UNITED STATES PATENT AND TRADEMARK OFFICE

10/591,607

Office Action Summary	Application No. 10/591,607	Applicant(s) LOPATIN, SERGEJ	
	Examiner BRYAN P. GORDON	Art Unit 2837

Figure A

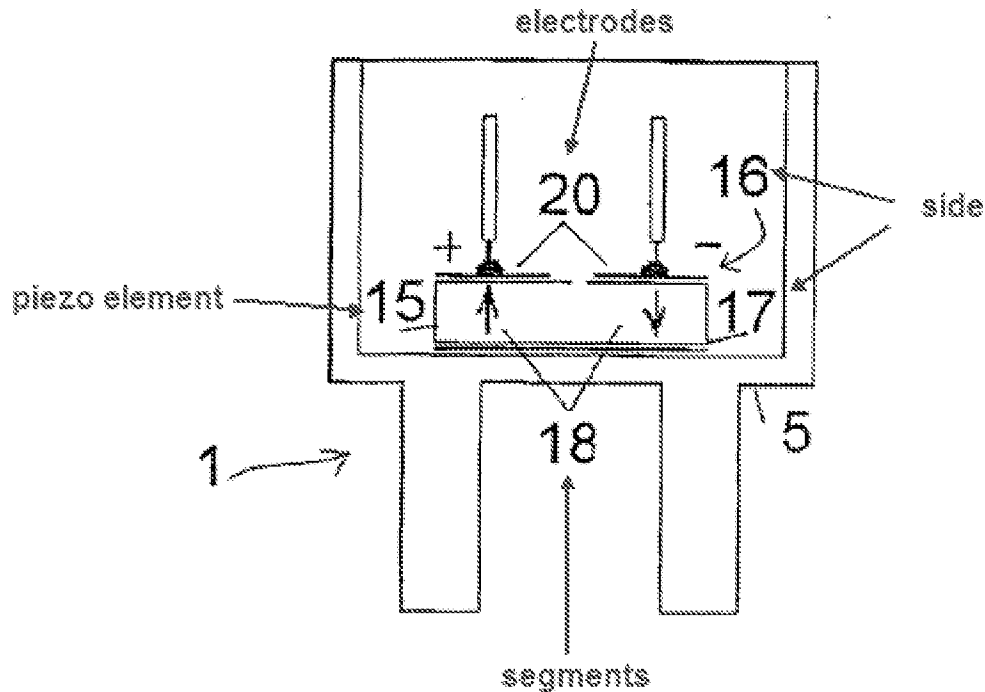
13. This is the applicant's apparatus for determining and/or monitoring a process variable of a medium. The device contains a piezo element which contains two segments. The applicant claims the two segments of the piezo element are connected

in series. Each segment is polarized in an opposite direction as indicated by the arrows.

Figure B

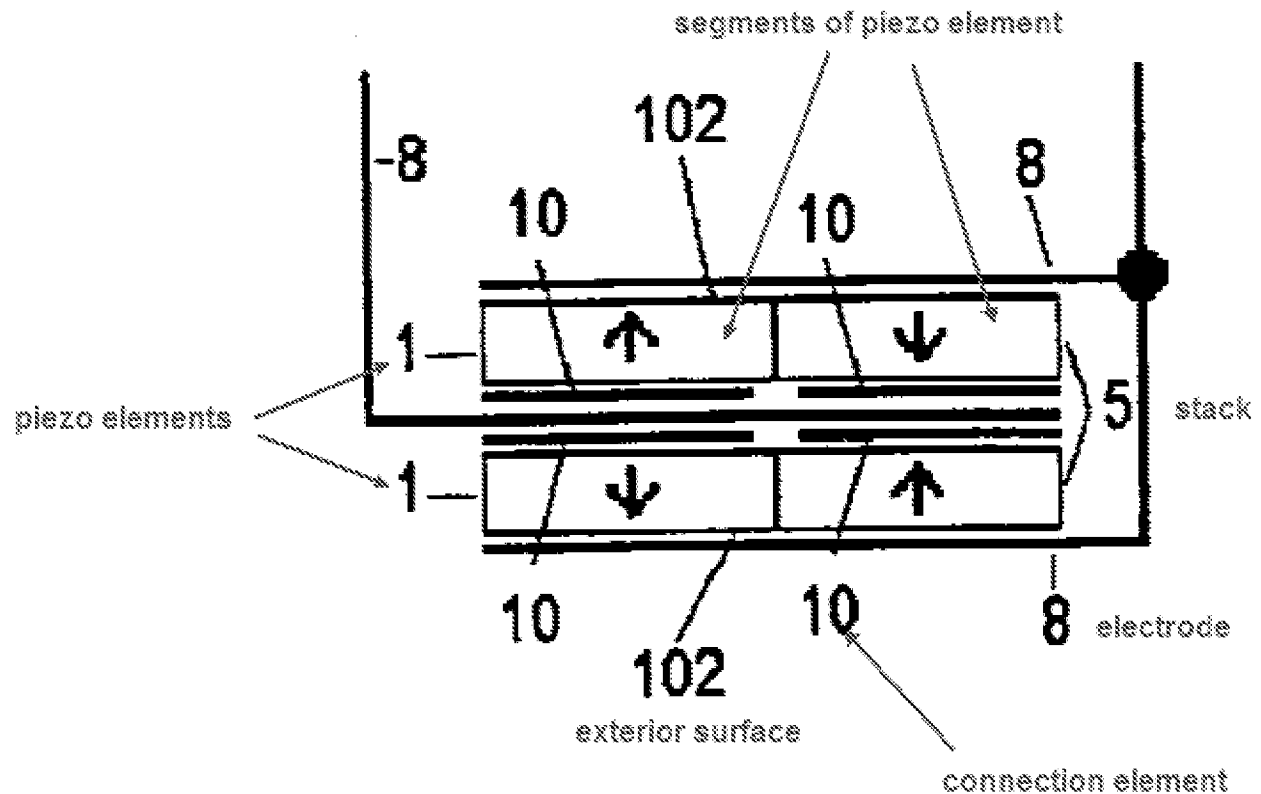
14. Figure B shows Lopatin's device in which two piezoelectric elements are stacked. Looking at the top piezoelectric element Lopatin's device has the same structure as the applicant's claim. One of ordinary skill in the art can conclude that the segments of Lopatin's would be connected in series since segments are not stacked on top of each other but rather adjacent to each other just like the applicant's device. Therefore, Lopatin does meet the applicant's limitation. Furthermore, It has been held that where

the structure recited in a reference is the same as the claimed structure, claimed properties and functions are presumed to be inherent (*In re Best*, 195 USPQ 430, 433).
